BCA ASSESSMENT REPORT

12-16 Bent Street, Lindfield

Project Number: 116856

Revision: 1.1

Figure 3: South elevation

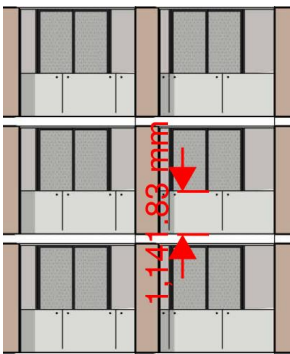
The development is Type A Construction and BCA Clause C3D7 requires suitable vertical and/or horizontal spandrel separation between the openings in the external walls on different storeys. The plans indicate suitable spandrels have not been provided by a combination of horizontal balcony slabs which achieve 1100mm length and external walls beneath windows which have a minimum of 900mm high with 600mm above the slab, therefore not complying with this Clause. **Following options apply:**

- + Amend design to suit compliance requirement, or
- + Fire Safety Engineer to review and confirm if a performance solution is feasible (BCA Clause C3D7).
- + **As the proposed development is over 25m, sprinklers are therefore required. If the proposed building is provided with a AS 2118.1:2017 sprinkler system installed throughout; spandrels are therefore not required.**

Figure 4: Level 01

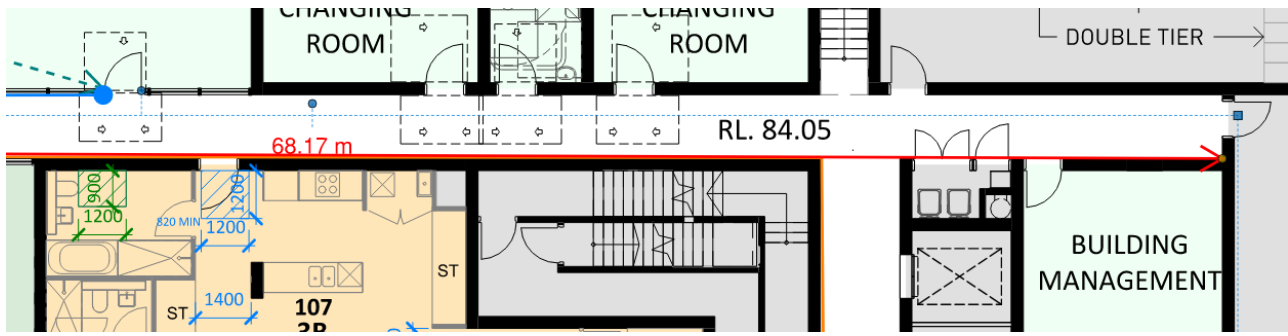
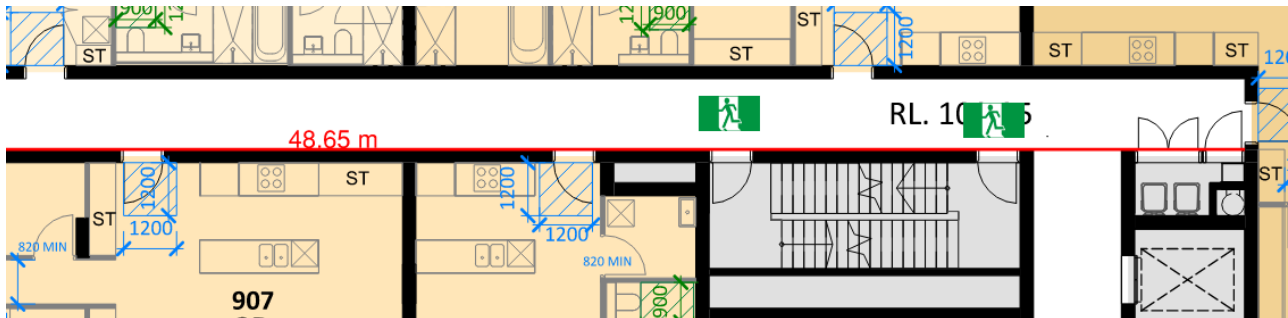
In accordance with BCA Clause C3D15, in a Class 2 or 3 building, a public corridor if more than 40 m in length, must be divided at intervals of not more than 40 m with smoke-proof walls complying with S11C2. The smoke corridors located on Levels 01 and 09 have a length greater than 40m, therefore not complying with Clause. Design amendments required to achieve compliance, must be divided at intervals of not more than 40m.

Figure 6: Level 01 point of discharge from Fire Isolated exits

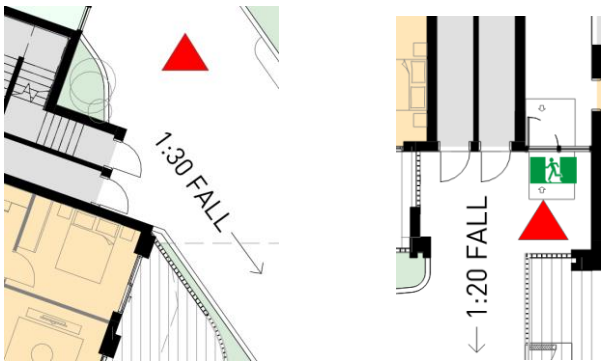
However, as the path of travel from the point of discharge of the fire isolated exits on the Ground Floor and Level 01 pass within 6m of an external wall of any part of an external wall of the same building, it must therefore be protected in accordance with BCA Clause C4D5 by either:

- + Internal or external wall-wetting sprinklers as appropriate used with windows that are automatic closing or permanently fixed in the closed position; or
- + -/60/- fire windows that are automatic closing or permanently fixed in the closed position; or
- + -/60/- automatic closing fire shutters or

Alternatively, (if feasible) a fire engineered performance solution would be required (BCA Clause C4D5).

Figure 7: Level 01 Fire Pump room

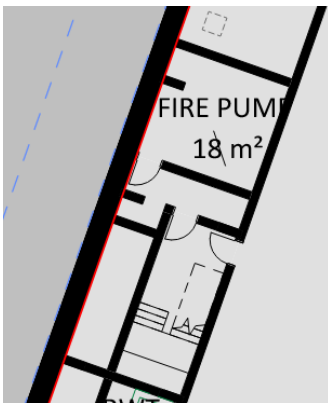
Furthermore it should be noted that proposed Fire Pump room located on Level 01 has only provided one (1) exit in lieu of the required two (2) exits in accordance with BCA Clause D2D3. Therefore not complying with this Clause. **Following options apply:**

- + Amend design to suit compliance requirement, i.e., add a door from the pump room to the carpark, or
- + Fire Safety Engineer to review and confirm if a performance solution is feasible (BCA Clause D2D3).

Figure 8: Entrance doorway Level 01 **Figure 9:** Entrance doorway Level 02

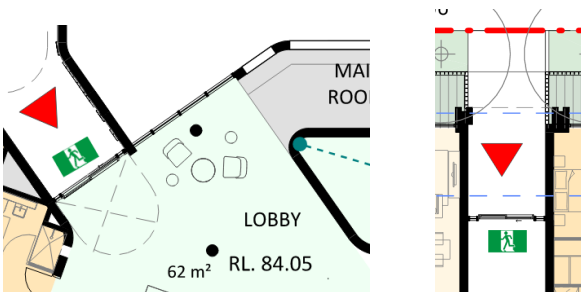
In accordance with BCA Clause D3D24 a doorway serving as a required exit or forming part of a required exit must not be fitted with a sliding door unless it leads directly to a road or open space and the door is able to be opened manually under a force of not more than 110 N and be openable under fire trip. **Further information of door hardware is required for assessment for Communal corridor doorways located on Level 01 and Level 02. Fire Engineering may be required at the CC stage.**

Figure 10: Threshold ramp Level 01

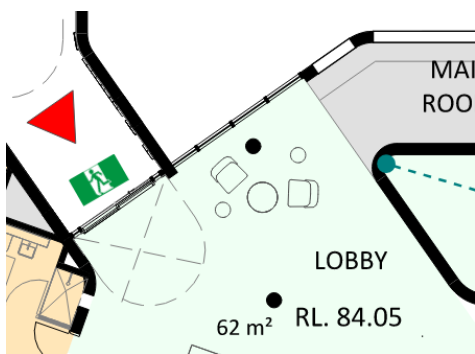
BCA Clause D3D16 requires that a threshold of a doorway must not incorporate a step or ramp at any point closer to the doorway than the width of the door leaf unless a building is required to be accessible. **Further information of the gradient of the threshold ramps is required for assessment for the Communal corridor doorways located on Level 01 and Level 02.**

Figure 12: Basement Level 01 Carpark

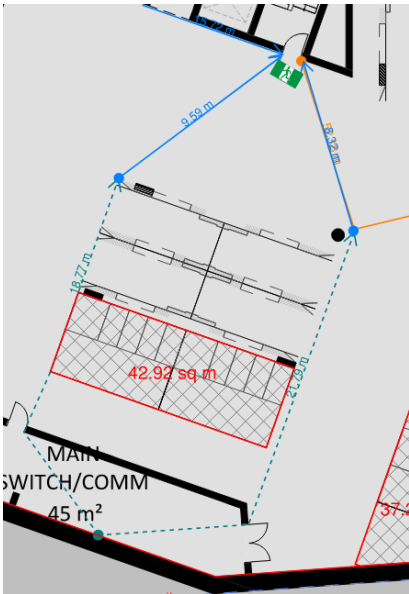
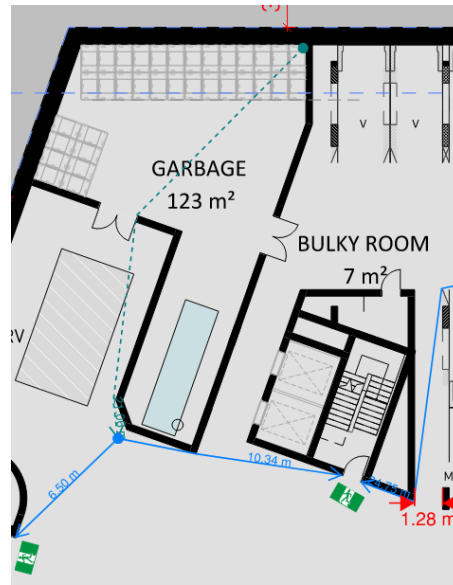
It will be necessary to undertake a Fire Engineered Performance Solution to permit the extended travel distances to the following locations:

- + BCA Clause D2D5 – Exit travel distance
 - o **To permit an exit travel distance of up to 25m in lieu of 20m within the Basement and Ground Floor Carpark storeys.**

Figure 14: Level 01

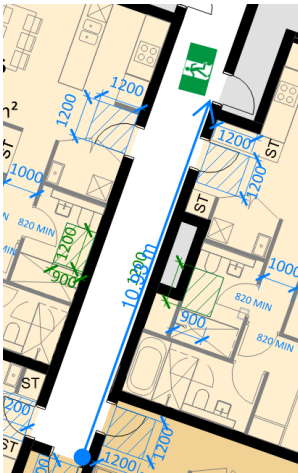
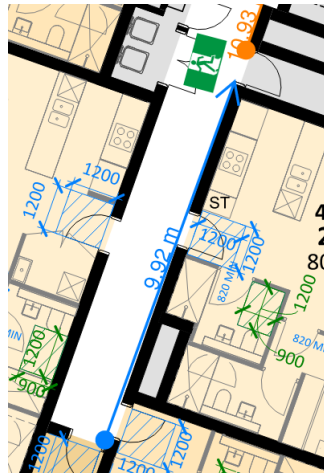
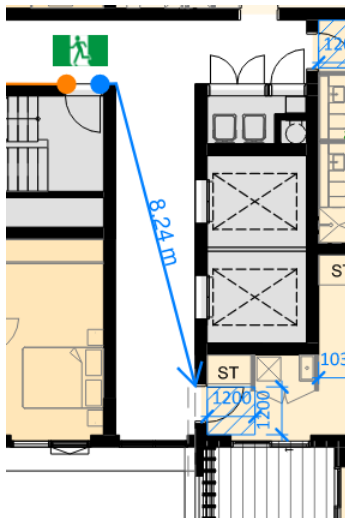
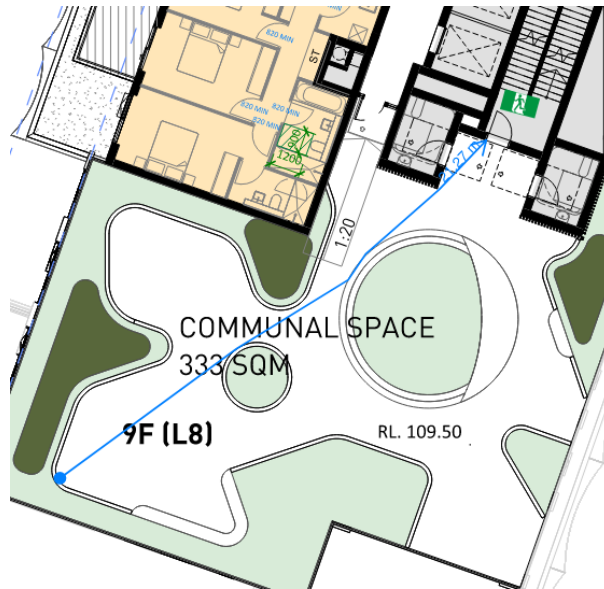
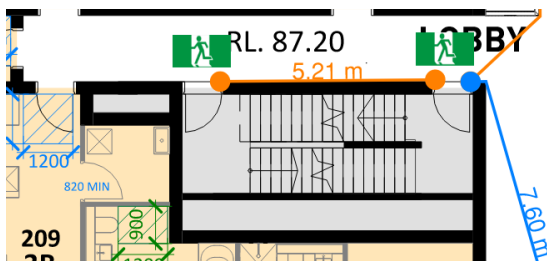
It will be necessary to undertake a Fire Engineered Performance Solution to permit the extended travel distances within the following locations:

- + BCA Clause D2D5 – Exit travel distance
 - o To permit an exit travel distance of up to 11m in lieu of 6m within Level 01 to Level 03.
 - o To permit an exit travel distance of up to 10m in lieu of 6m within Level 04 to Level 05.
 - o To permit an exit travel distance of up to 9m in lieu of 6m within Level 02 to Level 09.
 - o To permit an exit travel distance of up to 23m in lieu of 20m within Communal Space Level 09.
- + BCA Clause D2D6 – Distance between alternative exits
 - o To permit an exit travel distance between alternative exits of up to 5m in lieu of the minimum requirement of 9m for Levels 02 to Levels 10.

Figure 19: Level 02

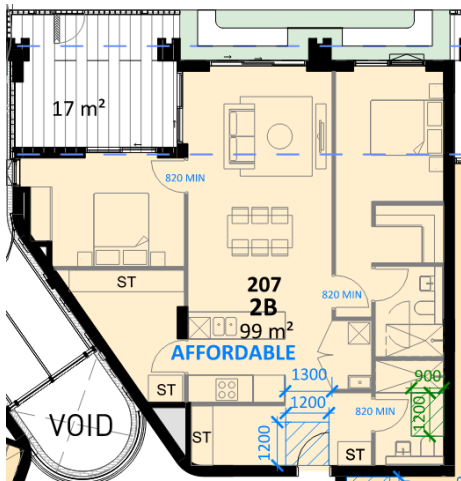
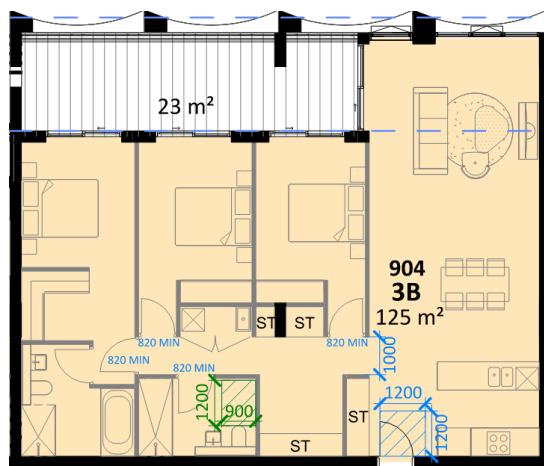
In accordance with BCA Clause F6D2 and F6D3 natural light is required to all habitable rooms within a Class 2 building, with the area of the doors and windows (exclusive of any framing members, glazing bars or other obstructions) required to be not less than 10% of the floor area. The plans have been assessed which reveals not all habitable spaces are served by windows or glazed doors. The area of concern are the study nooks provided within the SOU's which have not been provided with any natural lighting, therefore not complying with this Clause. Design amendments are required to achieve compliance.

Figure 21: Level 04

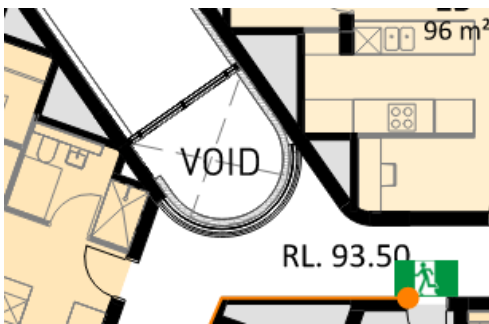
As the proposed development consists of an atrium, BCA Part G3 Atrium construction, requires an atrium to be separated from the remainder of the building, have a horizontal diameter less than 6m, bounding wall construction and fire and smoke control systems. Proposed Atrium is to be reviewed by the project Fire Safety Engineer.
